# UNITED STATES PATENT AND TRADEMARK OFFICE

10/593,535

<b>Office Action Summary</b>	<b>Application No.</b> 10/593,535	<b>Applicant(s)</b> TAKAYAMA ET AL.	
	<b>Examiner</b> DAVID GOODWIN	<b>Art Unit</b> 2818

**DETAILED ACTION**

FIG. 5

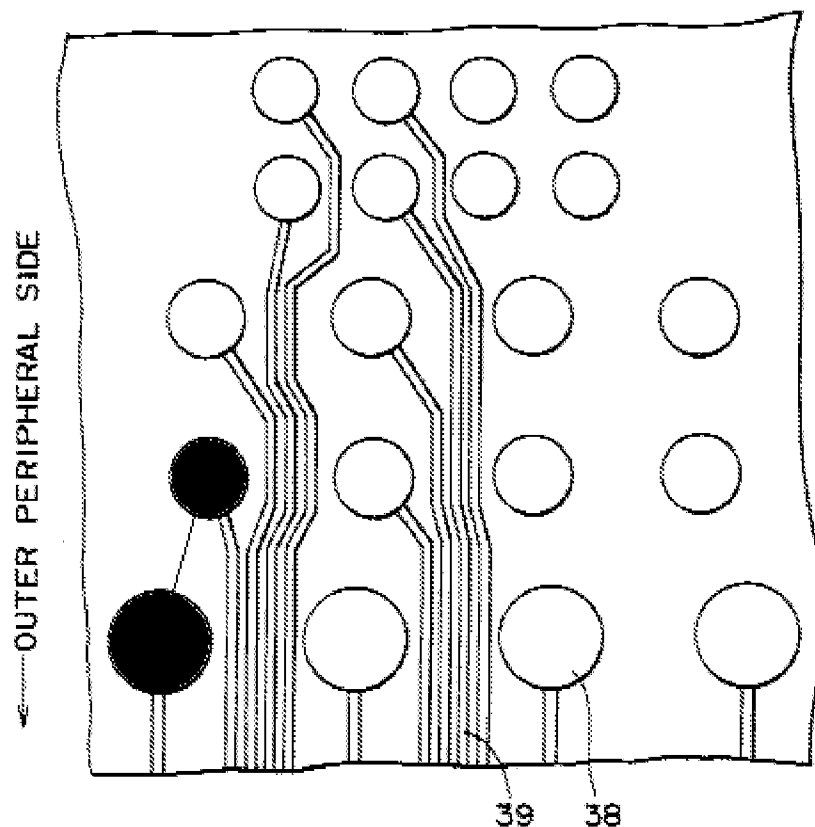
4. Nishiyama teaches an electronic component. Said component comprises A plurality of circuit elements (39) on one surface of a substrate (33), the circuit elements being resistive (fig 5). A plurality of electrode pairs (38) on the one surface of the substrate the electrode pairs being respectively connected to circuit elements (fig 5). A plurality of lands (38) include first lands and second lands, the second lands have a larger area than the first lands (fig 5). The circuit elements connected to the electrode pairs with the second lands are offset such that the circuit elements are laterally displaced from the shortest path between a center of each electrode of the electrode pairs in a plan view (fig 5) (column 6 lines 1-40).

5. Note: Referring to figure 5, a plurality of lands (38) is shown. Any two of said lands (39) is a pair of lands. Said pair of lands is connected to circuit elements (39). Said circuit elements are displaced from the shortest path between the lands, said shortest path being the straight line path intersecting the center of a given electrode pair.

11. Note the pair of blackened electrodes above having a first land and a second land (fig 5). Said pair of electrodes are connected to circuit elements. Said circuit elements connected to the pair of electrodes, having the first and second lands, are laterally displaced from the shortest path connecting the center of electrode of the electrode pair (shown above).
